ACCESSIBILITY ASSESSMENT

ADA TITLE III ASSESSMENT

Ridgeview Elementary School

December 12, 2024

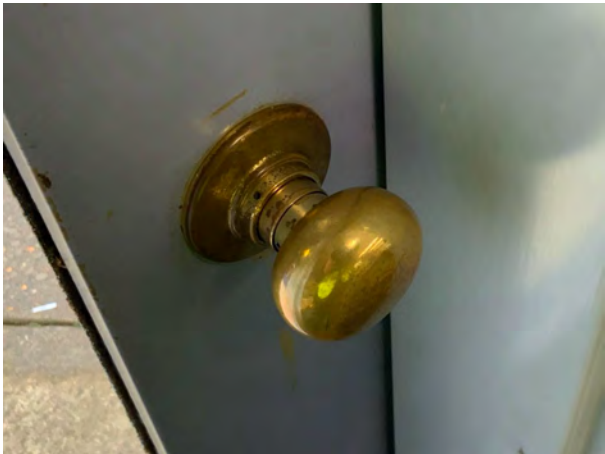
The hardware at the accessible door requires tight grasping and twisting of the wrist to operate.

Remove hardware and replace with hardware that has a shape that is easy to grasp such as lever, push-type or U-shaped handles. Handles, pulls, latches, locks, and other operable parts on doors and gates shall be compliant. Operable parts of such hardware shall be 34" minimum and 48" maximum above the finish floor or ground. Where sliding doors are in the fully open position, operating hardware shall be exposed and usable from both sides. [EXCEPTIONS: 1. Existing locks shall be permitted in any location at existing glazed doors without stiles, existing overhead rolling doors or grilles, and similar existing doors or grilles that are designed with locks that are activated only at the top or bottom rail. 2. Access gates in barrier walls and fences protecting pools, spas, and hot tubs shall be permitted to have operable parts of the release of latch on self-latching devices at 54" maximum above the finish floor or ground provided the self-latching devices are not also self-locking devices and operated by means of a key, electronic opener, or integral combination lock.]

Photos for Barrier ID: AX516400

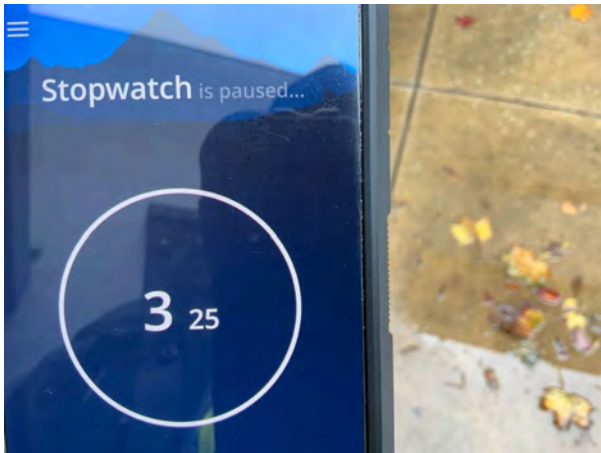
Assembly	Entrance to Building
Type	Building Entrance - Door
ADA Standard	404.2.8
Barrier Detail	
The accessible door with door closer has a sweep period of less than 5 seconds from 90 degrees to a position 12 degrees from latch.	
Location Description	East Gym to Playground Entrance
Observed	Nov 3, 2024 by Jeffrey.solis@bureauveritas.com
Site Conditions	
The door closing speed is 3.25 seconds from 90 degrees to a position 12 degrees from latch.	
Resolution	
Adjust closer or remove and replace closer to ensure that the door has a closure time of at least 5 seconds within 12 degrees of the latch. Door closers and gate closers shall be adjusted so that from an open position of 90 degrees, the time required to move the door to a position of 12 degrees from the latch is 5 seconds minimum.	
Quantity	
1 EA	
Priority	1

Photos for Barrier ID: AX519047

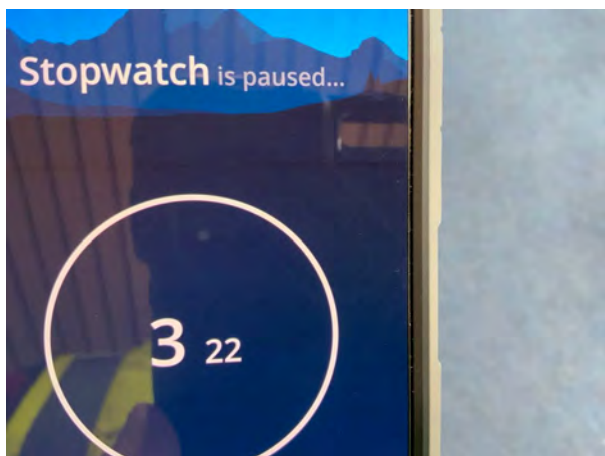
Assembly	Entrance to Building
Type	Building Entrance - Door
ADA Standard	404.2.8
Barrier Detail	
The accessible door with door closer has a sweep period of less than 5 seconds from 90 degrees to a position 12 degrees from latch.	
Location Description	East Gym to Playground Entrance
Observed	Nov 5, 2024 by Jeffrey.solis@bureauveritas.com
Site Conditions	
The door closing speed is 3.22 seconds from 90 degrees to a position 12 degrees from latch.	
Resolution	
Adjust closer or remove and replace closer to ensure that the door has a closure time of at least 5 seconds within 12 degrees of the latch. Door closers and gate closers shall be adjusted so that from an open position of 90 degrees, the time required to move the door to a position of 12 degrees from the latch is 5 seconds minimum.	
Quantity	
1 EA	
Priority	1

Photos for Barrier ID: AX516360

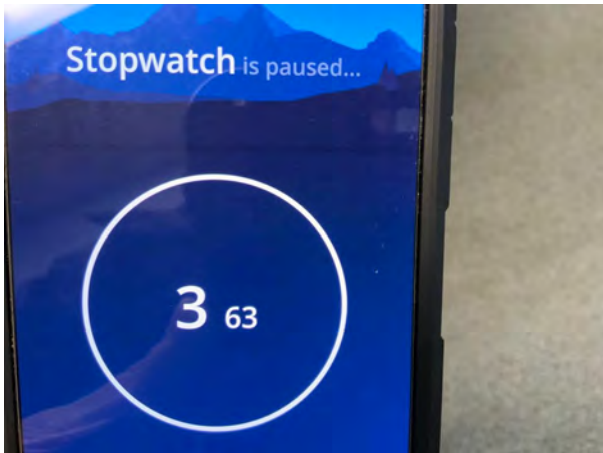
Assembly	Entrance to Building
Type	Building Entrance - Door
ADA Standard	404.2.8
Barrier Detail	
The accessible door with door closer has a sweep period of less than 5 seconds from 90 degrees to a position 12 degrees from latch.	
Location Description	Office Entrance
Observed	Nov 3, 2024 by Jeffrey.solis@bureauveritas.com
Site Conditions	
The door closing speed is 3.63 seconds from 90 degrees to a position 12 degrees from latch.	
Resolution	
Adjust closer or remove and replace closer to ensure that the door has a closure time of at least 5 seconds within 12 degrees of the latch. This barrier must be removed in conjunction with barrier ID 516359. The cost of this barrier removal is covered under ID 516359, and therefore, the cost of this ID is shown as \$0. Door closers and gate closers shall be adjusted so that from an open position of 90 degrees, the time required to move the door to a position of 12 degrees from the latch is 5 seconds minimum.

Photos for Barrier ID: AX516363

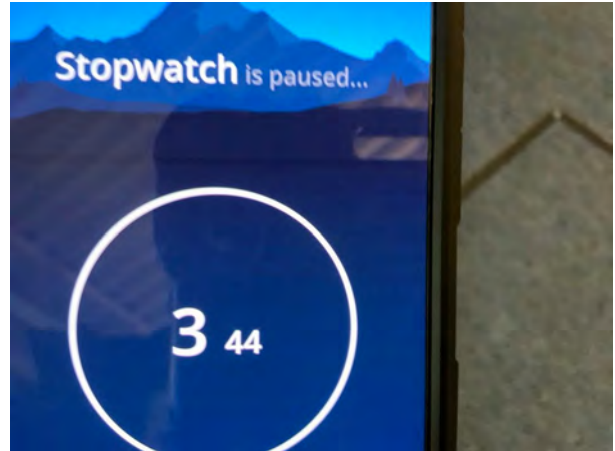
Assembly	Entrance to Building
Type	Building Entrance - Door
ADA Standard	404.2.8
Barrier Detail	
The accessible door with door closer has a sweep period of less than 5 seconds from 90 degrees to a position 12 degrees from latch.	
Location Description	Office Entrance
Observed	Nov 3, 2024 by Jeffrey.solis@bureauveritas.com
Site Conditions	
The door closing speed is 3.44 seconds from 90 degrees to a position 12 degrees from latch.	
Resolution	
Adjust closer or remove and replace closer to ensure that the door has a closure time of at least 5 seconds within 12 degrees of the latch. This barrier must be removed in conjunction with barrier ID 516362. The cost of this barrier removal is covered under ID 516362, and therefore, the cost of this ID is shown as \$0. Door closers and gate closers shall be adjusted so that from an open position of 90 degrees, the time required to move the door to a position of 12 degrees from the latch is 5 seconds minimum.

Photos for Barrier ID: AX516362

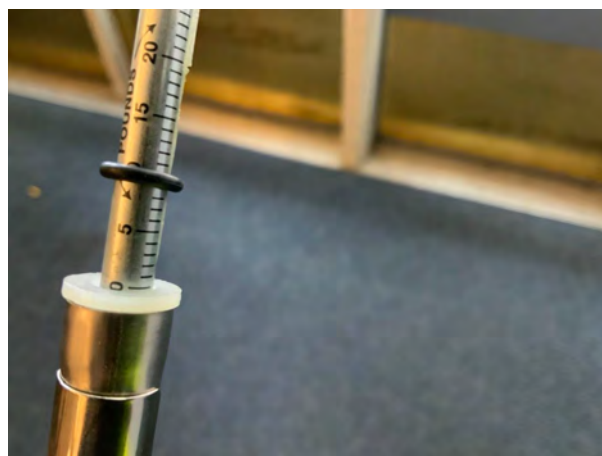
Assembly	Entrance to Building
Type	Building Entrance-Door
ADA Standard	Oregon Structural Specialty Code 1102.1.2.
Barrier Detail	
OREGON: The hinged accessible exterior door requires more than 8.5 pounds of pressure to operate	
Location Description	Office Entrance
Observed	Nov 3, 2024 by Jeffrey.solis@bureauveritas.com
Site Conditions	The door opening force is 9 pounds.
Resolution	
Adjust the closer or replace with an exterior door that requires no more 8.5 pounds of force for pushing or pulling the door open. The opening force of doors along an accessible route shall be as follows: 1. Exterior doors: 8.5 pounds maximum (lbf) (37.8 N). 2. Interior doors: 5 pounds maximum (lbf) (22.2 N). 3. Stairway doors at pressurized stair enclosures: 15 pounds maximum (6.8 kg) at exterior doors. 4. Where environmental conditions require greater closing pressure, power-operated doors shall be used within the accessible route. [Exception: The force required to retract latch bolts or disengage other devices that hold the door or gate in a closed position shall not apply to panic hardware, delayed egress devices or fire-rated hardware.]

Photos for Barrier ID: AX516402

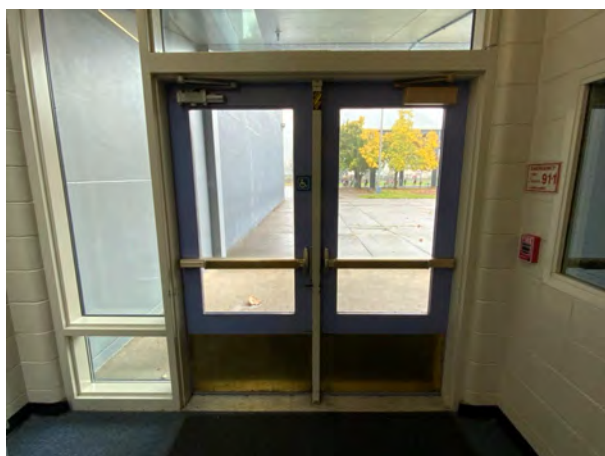
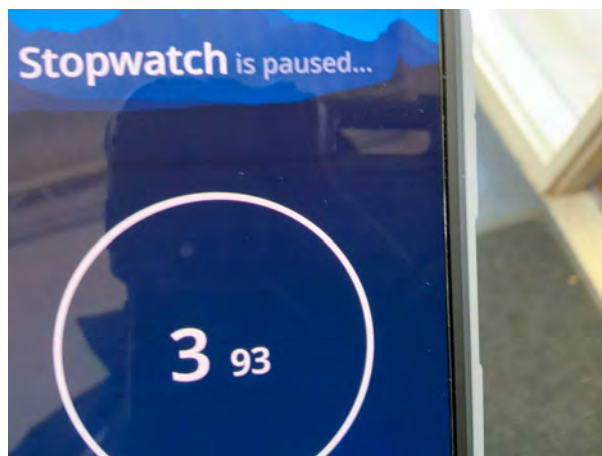
Assembly	Entrance to Building
Type	Building Entrance - Door
ADA Standard	404.2.8
Barrier Detail	
The accessible door with door closer has a sweep period of less than 5 seconds from 90 degrees to a position 12 degrees from latch.	
Location Description	West Gym to Playground Entrance
Observed	Nov 3, 2024 by Jeffrey.solis@bureauveritas.com
Site Conditions	
The door closing speed is 3.93 seconds from 90 degrees to a position 12 degrees from latch.	
Resolution	
Adjust closer or remove and replace closer to ensure that the door has a closure time of at least 5 seconds within 12 degrees of the latch. This barrier must be removed in conjunction with barrier ID 516401. The cost of this barrier removal is covered under ID 516401, and therefore, the cost of this ID is shown as \$0. Door closers and gate closers shall be adjusted so that from an open position of 90 degrees, the time required to move the door to a position of 12 degrees from the latch is 5 seconds minimum.

Photos for Barrier ID: AX516401

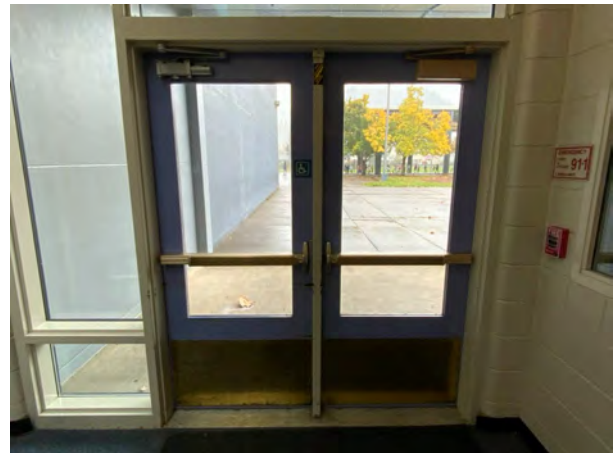
Assembly	Entrance to Building
Type	Building Entrance-Door
ADA Standard	Oregon Structural Specialty Code 1102.1.2.
Barrier Detail	
OREGON: The hinged accessible exterior door requires more than 8.5 pounds of pressure to operate	
Location Description	West Gym to Playground Entrance
Observed	Nov 3, 2024 by Jeffrey.solis@bureauveritas.com
Site Conditions	The door opening force is 10 pounds.
Resolution	
Adjust the closer or replace with an exterior door that requires no more 8.5 pounds of force for pushing or pulling the door open. The opening force of doors along an accessible route shall be as follows: 1. Exterior doors: 8.5 pounds maximum (lbf) (37.8 N). 2. Interior doors: 5 pounds maximum (lbf) (22.2 N). 3. Stairway doors at pressurized stair enclosures: 15 pounds maximum (6.8 kg) at exterior doors. 4. Where environmental conditions require greater closing pressure, power-operated doors shall be used within the accessible route. [Exception: The force required to retract latch bolts or disengage other devices that hold the door or gate in a closed position shall not apply to panic hardware, delayed egress devices or fire-rated hardware.]

Photos for Barrier ID: AX519072

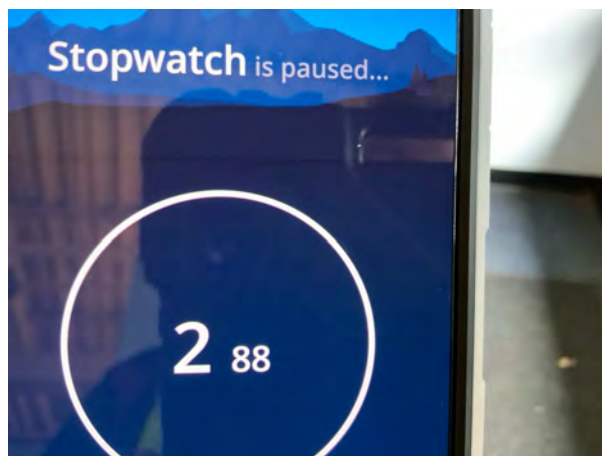
Assembly	Entrance to Building
Type	Building Entrance - Door
ADA Standard	404.2.8
Barrier Detail	
The accessible door with door closer has a sweep period of less than 5 seconds from 90 degrees to a position 12 degrees from latch.	
Location Description	West Hallway to Playground Entrance
Observed	Nov 5, 2024 by Jeffrey.solis@bureauveritas.com
Site Conditions	
The door closing speed is 2.88 seconds from 90 degrees to a position 12 degrees from latch.	
Resolution	
Adjust closer or remove and replace closer to ensure that the door has a closure time of at least 5 seconds within 12 degrees of the latch. This barrier must be removed in conjunction with barrier ID 519071. The cost of this barrier removal is covered under ID 519071, and therefore, the cost of this ID is shown as \$0. Door closers and gate closers shall be adjusted so that from an open position of 90 degrees, the time required to move the door to a position of 12 degrees from the latch is 5 seconds minimum.

Photos for Barrier ID: AX519065

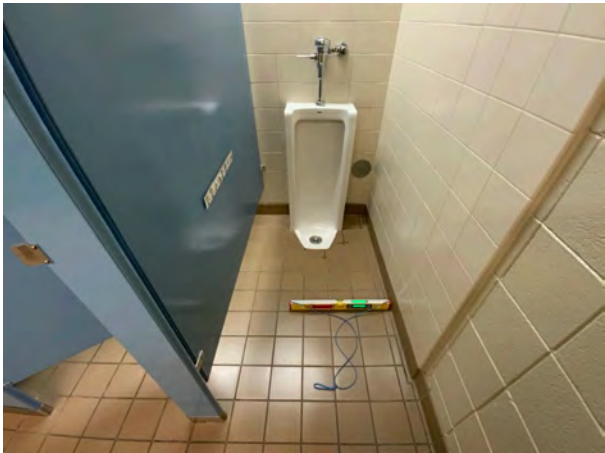
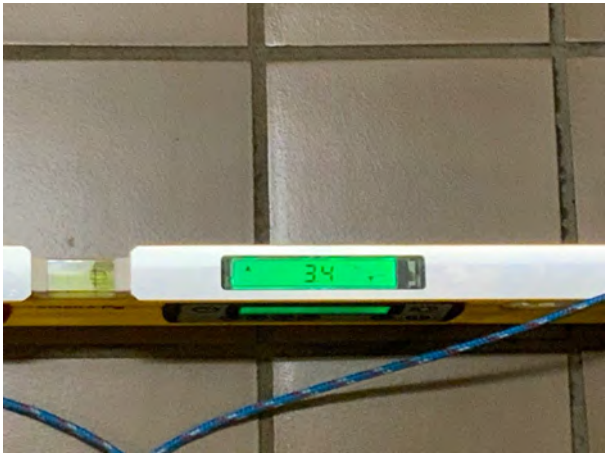
Assembly	Restroom
Type	Restroom/Bathroom - Unisex
ADA Standard	403.3
Barrier Detail	The slope of the floor surface is greater than 2% cross or 5% running
Location Description	Student - Boys Restroom (West)
Observed	Nov 5, 2024 by Jeffrey.solis@bureauveritas.com

Provide a floor surface with slopes no greater than 2% cross or 5% running. Ensure compliant thresholds.

Photos for Barrier ID: AX516433

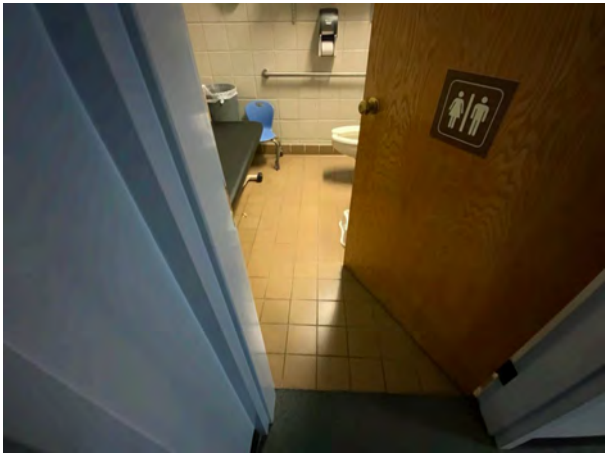
Assembly	Restroom
Type	Restroom/Bathroom - Door
ADA Standard	404.2.4
Barrier Detail	
The push side of the door does not have the required maneuvering clearances.	
Location Description	Staff - Left Restroom
Observed	Nov 3, 2024 by Jeffrey.solis@bureauveritas.com
Site Conditions	The side maneuvering clearance is 2-1/4" on the push side of the door.

Redesign to provide the required maneuvering clearance on the push side the door. The required depth of the maneuvering clearance is 48" minimum. The required side clearance is 12" minimum on the latch side of the door. Maneuvering clearance shall extend the full width of the doorway and the required latch side clearance. Floor or ground space within the required maneuvering clearance shall be maximum 1:48 (2.08%) slope. Changes in level are not permitted.
